Project No: 0110-464
Ethel Phillips ES Telecenter Upgrade Project
ADDENDUM NO. 2

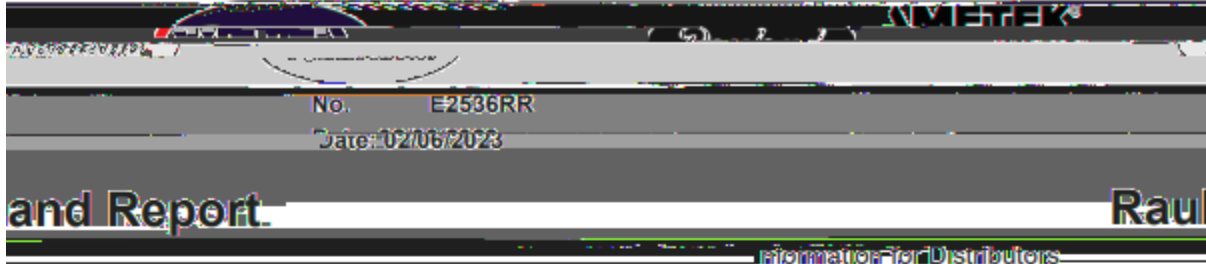
Question: TCC2011A is a discontinued part, replaced by TCC2011B. See Spec sheet attached
